WILLISTON DEVELOPMENT REVIEW BOARD STAFF REPORT

DP 24-15

99 Engineers Drive Addition

July 9, 2024

☒ **Street Trees**

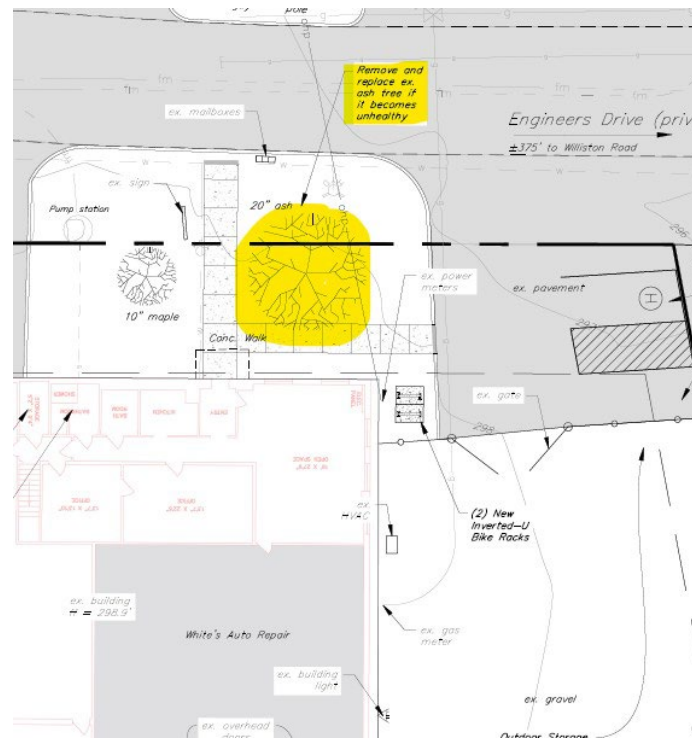
Compliance anticipated. WDB 26.11.2 requires street trees along the existing road frontage of redevelopment projects. The site has 2 existing trees along the existing 270' of frontage where 6 trees would normally be required. One of the existing trees is an ash tree.

The DRB recommended that additional street trees should not be provided along Engineers Drive but recommended that the existing ash tree should be removed and replaced with a different species due to the threat of the Emerald Ash Borer. The applicant has not proposed additional street trees and has stated that "the existing ash tree will be removed and replaced if it becomes unhealthy due to the Emerald Ash Borer."

The applicant shall replace the existing ash tree with a new street tree. Final plans shall include detail demonstrating compliance with WDB 26.4. See Condition 22.

Image below: Pink line shows edge of Class II wetland along the eastern property line.

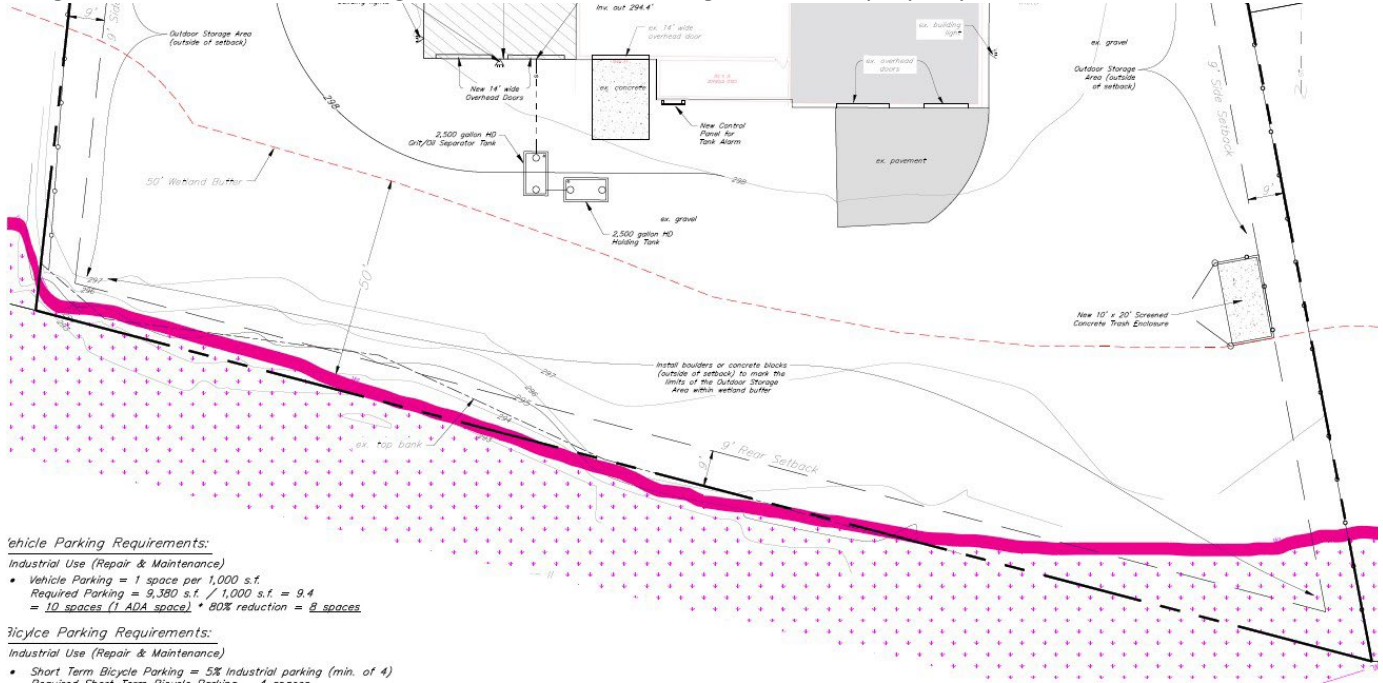
Compliance anticipated. The applicant must comply with wetland protections and delineate the edge of the Class II wetland to ensure the existing outdoor storage does not encroach upon it.

The applicant has submitted a site plan which delineates a Class II wetland and its associated 50' watershed protection buffer along the extent of the eastern property line. The parcel has historically had outdoor storage within the watershed protection buffer and possibly within the mapped wetland.

WDB 29.8.2 states that Class II wetlands are protected by state law and Williston's bylaw. Continued outdoor storage within the Class II wetland is not permitted.

WDB 29.9.9.2 allows nonconformities located in watershed protection buffers to be maintained, repaired, replaced and enlarged provided that the degree of nonconformity is not increased. WDB 29.9.7 requires that watershed protection buffers are marked on Final Plans and on the ground. The applicant has proposed outdoor storage within the 50' watershed protection buffer and has moved the proposed dumpster enclosure and snow storage out of the buffer. **Outdoor storage in the watershed buffer may continue, however the edge of the Class II wetland must be marked with boulders or concrete blocks on the ground and on final plans. See Condition 23.**

23. **The applicant shall delineate the Class II wetland using boulders or concrete blocks on the ground and on final plans.**
